ADDENDUM NO. 2

FY24 Stormwater Improvements

City of Seminole

July 29, 2024

GENERAL NOTES & LEGENDS

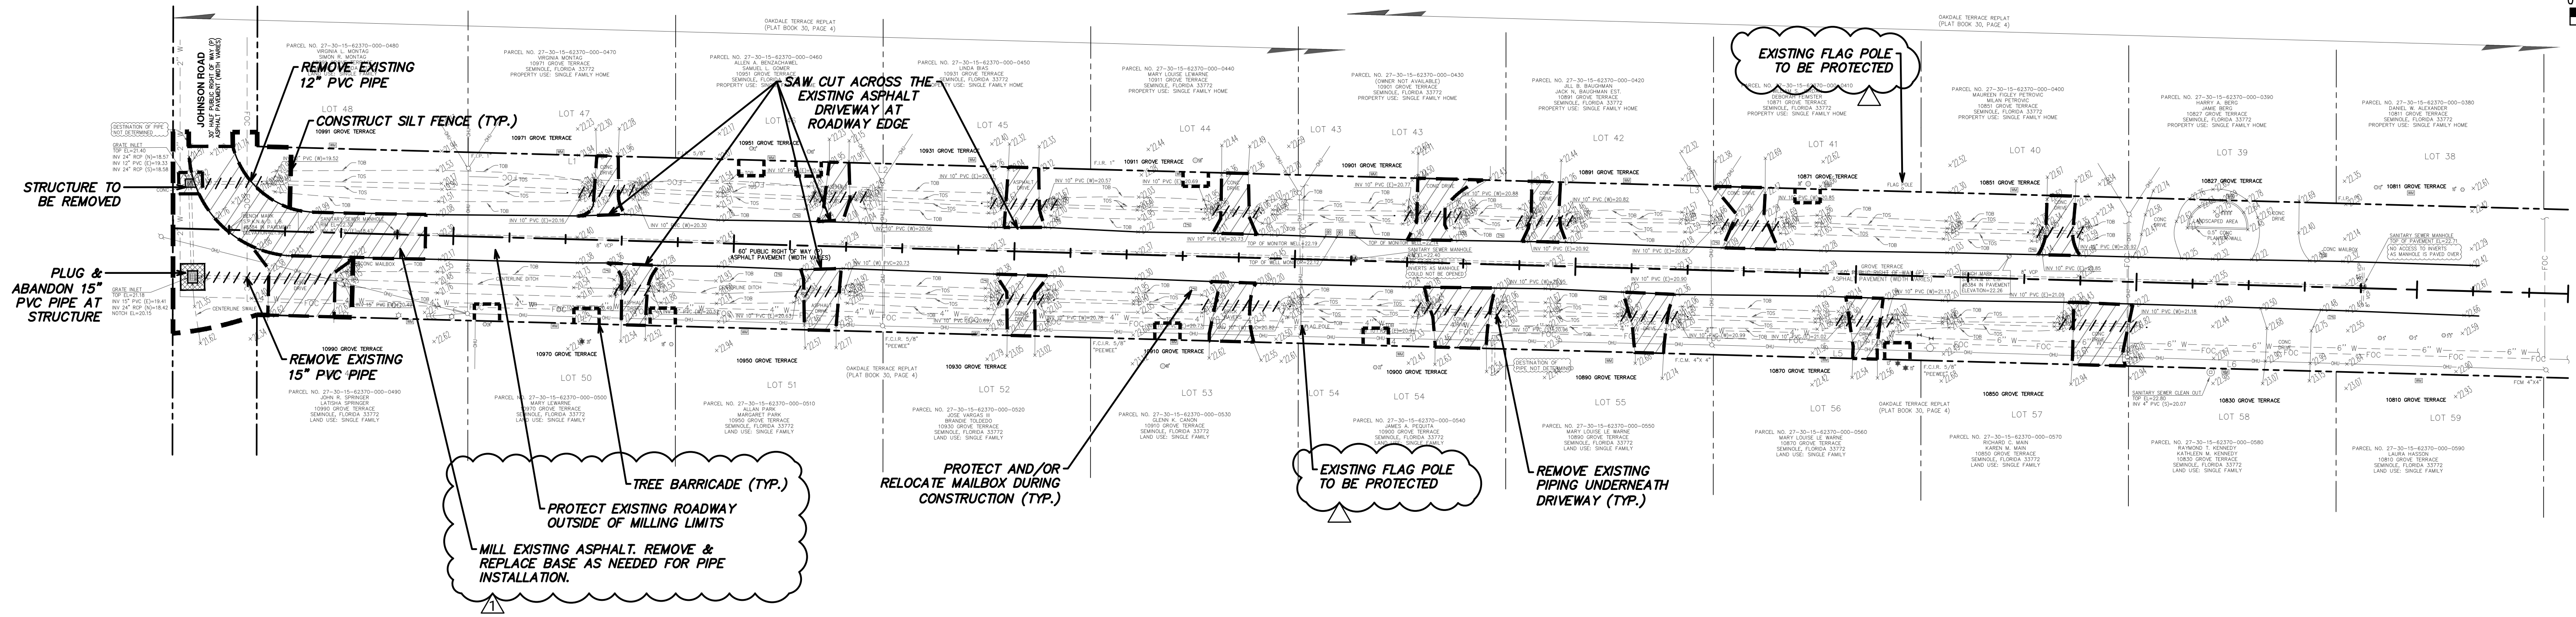
A. Sheet C2, General Notes & Legends

- a. Added additional SUE information to the SUE table.

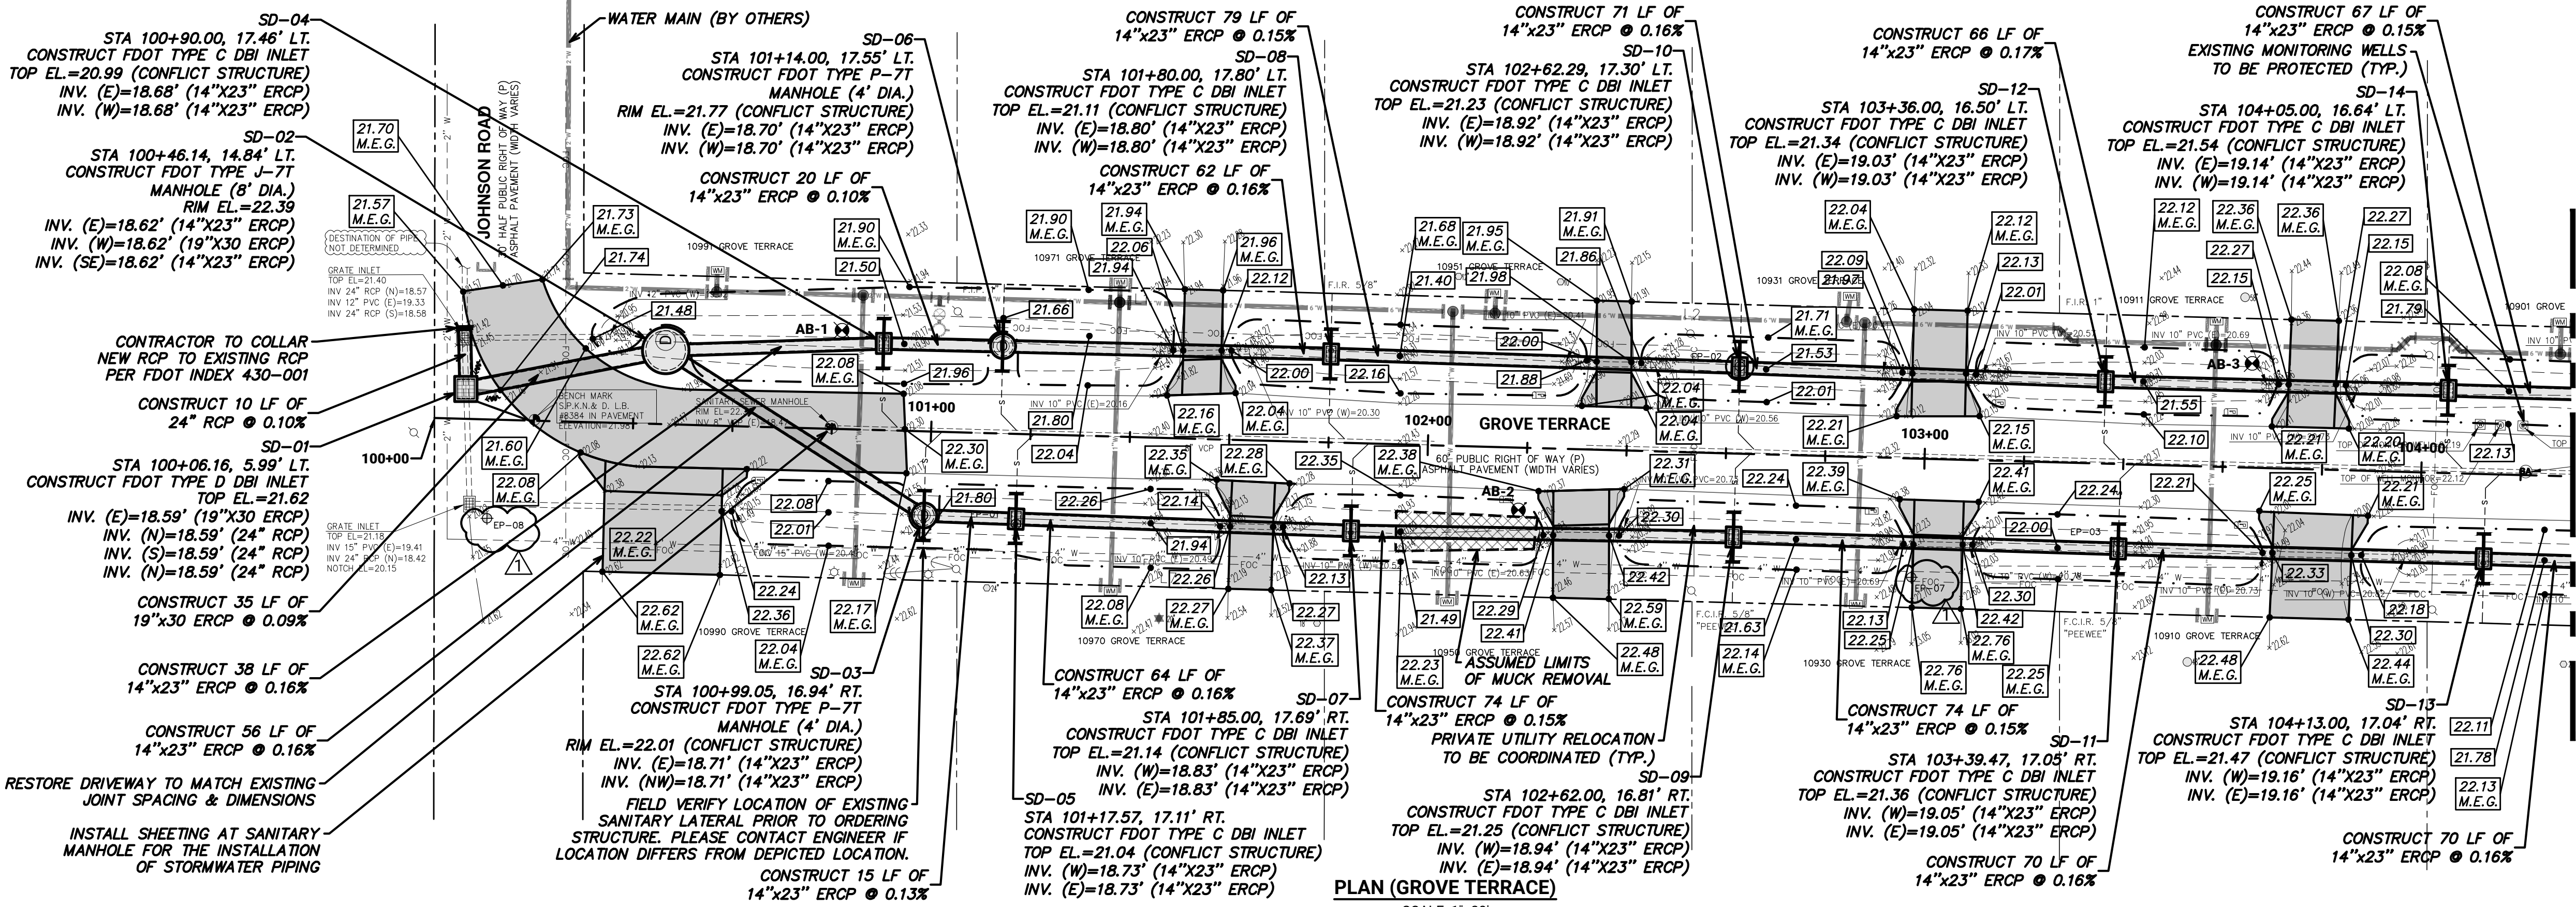
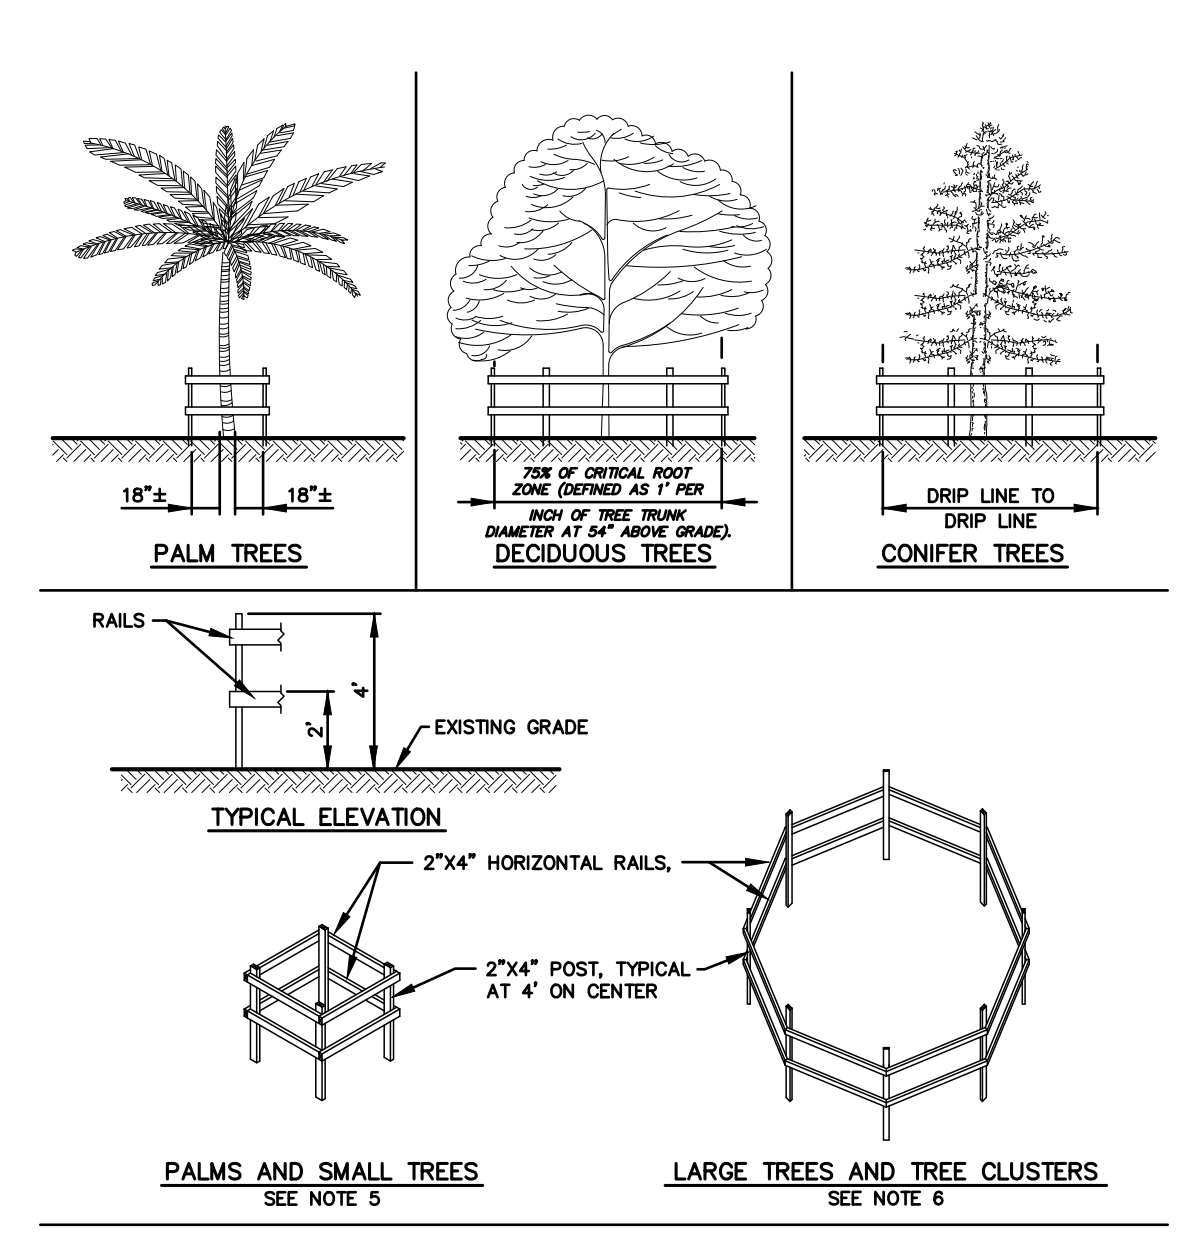
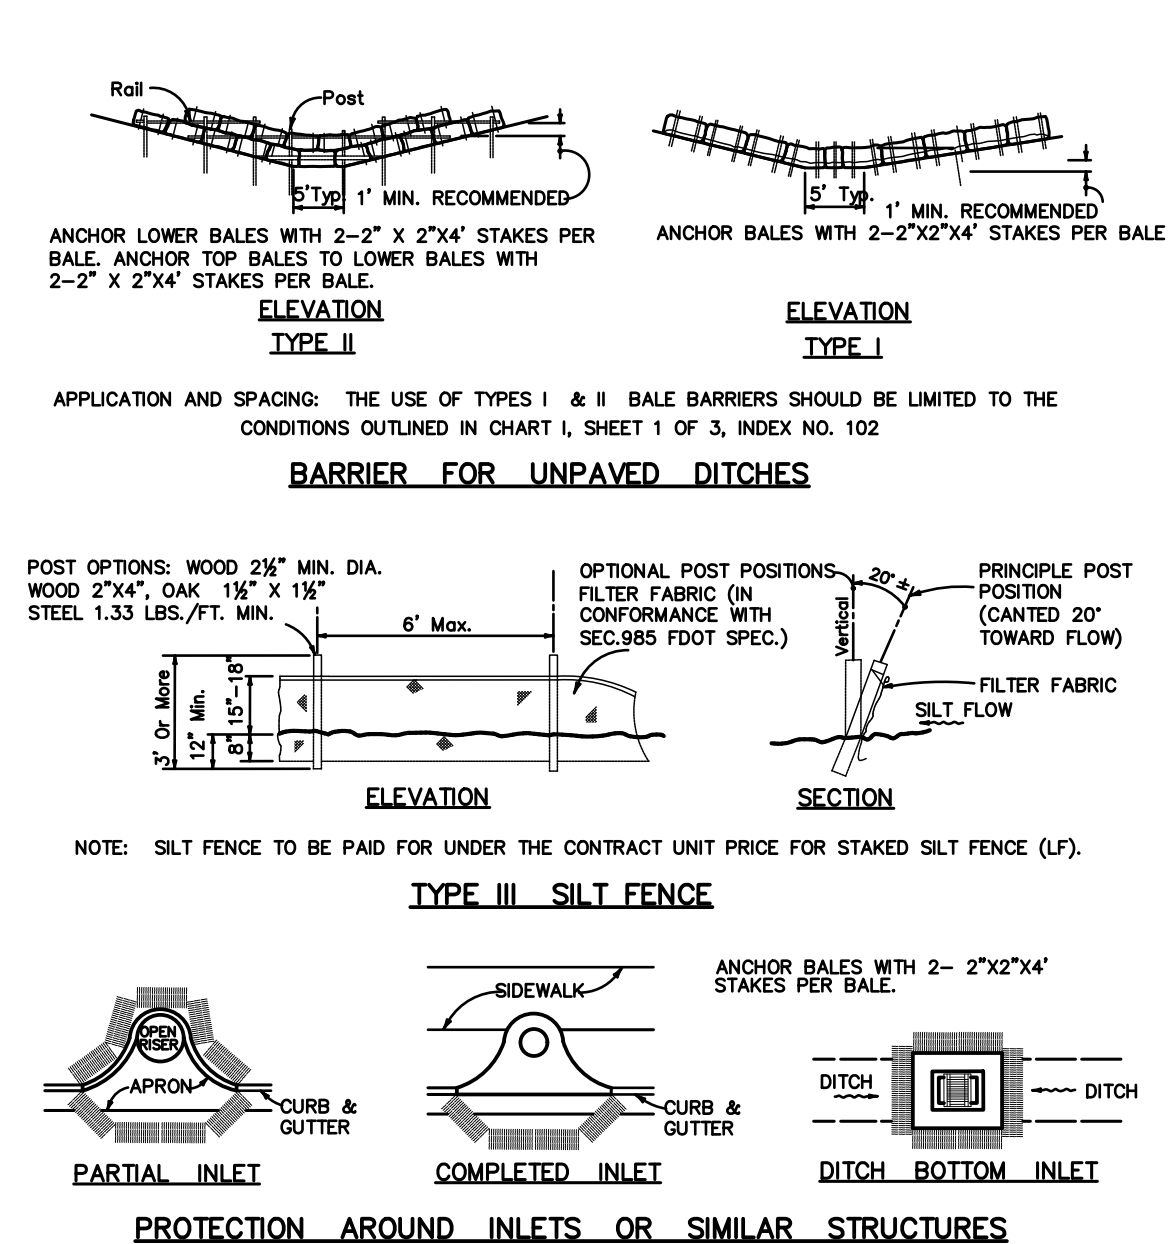
B. Sheet C5, Demolition & Erosion Control

- a. Added line type for tree barricades to the legend and a callout for the typical tree barricade.
- b. Added callout for the protection of the existing flag pole.
- c. Further clarification on the limits of roadway milling as well as a callout for the protection of the existing roadway outside of the milling limits.

RSQ.5 Plan sheet C5 does not clearly identify where tree protection and silt fencing are to be installed. Please provide this information.

Please reference the revised Sheet C5 legend for the line type depicting the tree barricades. Tree barricades shall terminate at the right-of-way limits.

Sheet C5 depicts the limits of silt fencing being located on the western end of the project.

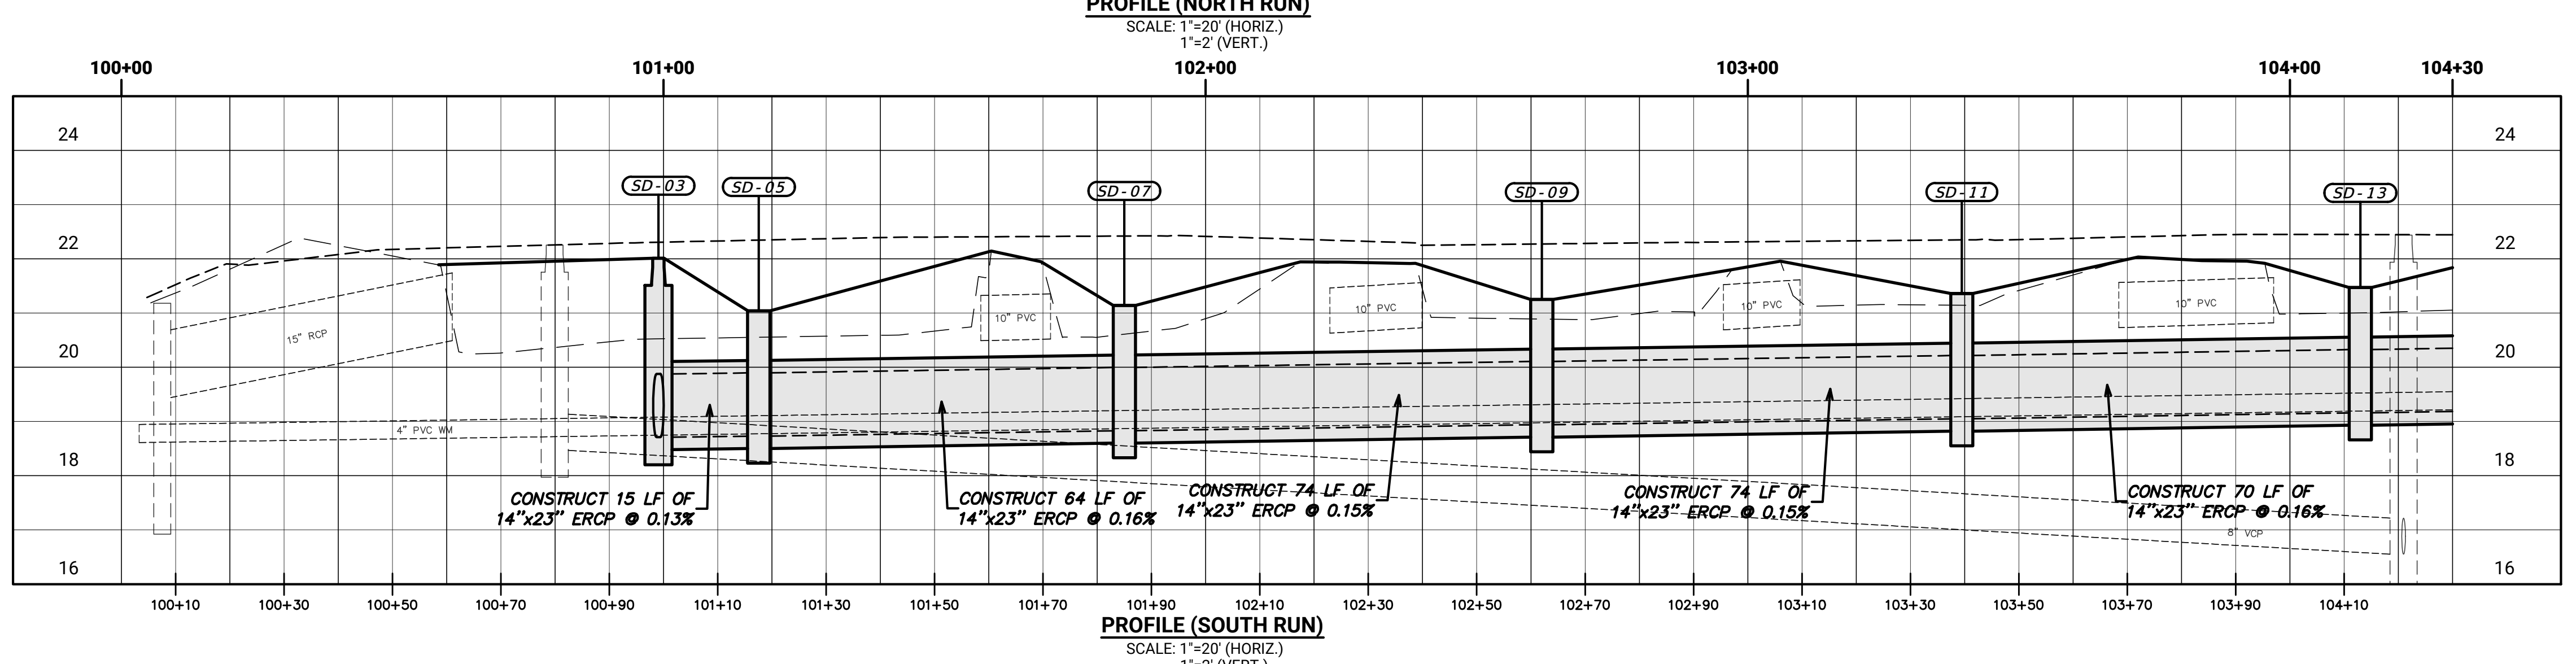
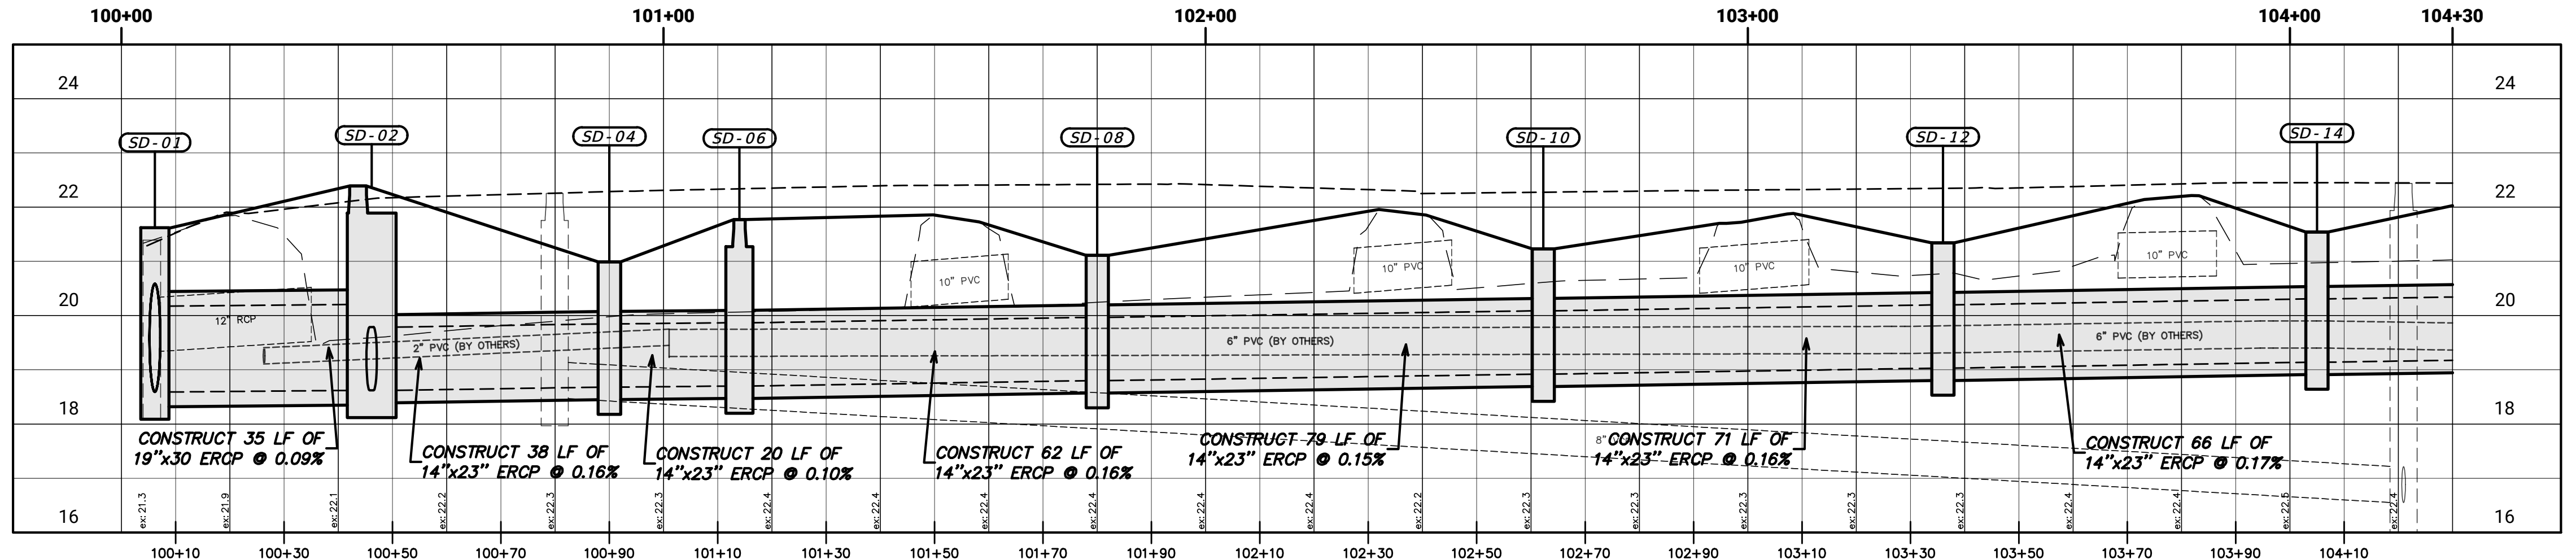
C. Sheet C6, Plan & Profile (Grove Terrace)

- a. Added notation that the Contractor shall verify the location of the existing sanitary laterals prior to the fabrication of stormwater structures.
- b. Added notation to clarify that the Contractor has the option to cast-in-place the stormwater structures if they so choose.
- c. Added notation clarifying that the existing sanitary lateral material is clay (VCP).
- d. Added notation clarifying that the existing VCP sanitary gravity system has been lined.
- e. Added locations of additional SUE activities.

- NOTES:**
- CONTRACTOR SHALL CONFIRM LOCATIONS OF SANITARY LATERALS PRIOR TO STRUCTURE FABRICATION. CONTRACTOR SHALL ADJUST STRUCTURE INVERTS ELEVATIONS TO MAINTAIN PIPE SLOPE. ANY DEVIANCE FROM THE LATERAL LOCATIONS DEPICTED ON PLANS SHALL BE BROUGHT TO THE ATTENTION OF THE ENGINEER.
 - CONTRACTOR HAS THE OPTION TO CAST-IN-PLACE STORMWATER CONFLICT STRUCTURES IN LIEU OF UTILIZING PRE-CAST STRUCTURES. REFERENCE DETAILS ON SHEET C11 FOR BOTH OPTIONS.
 - EXISTING SANITARY LATERAL MATERIAL IS CLAY (VCP).
 - EXISTING PINELLAS COUNTY VCP SANITARY GRAVITY SYSTEM IS LINED.
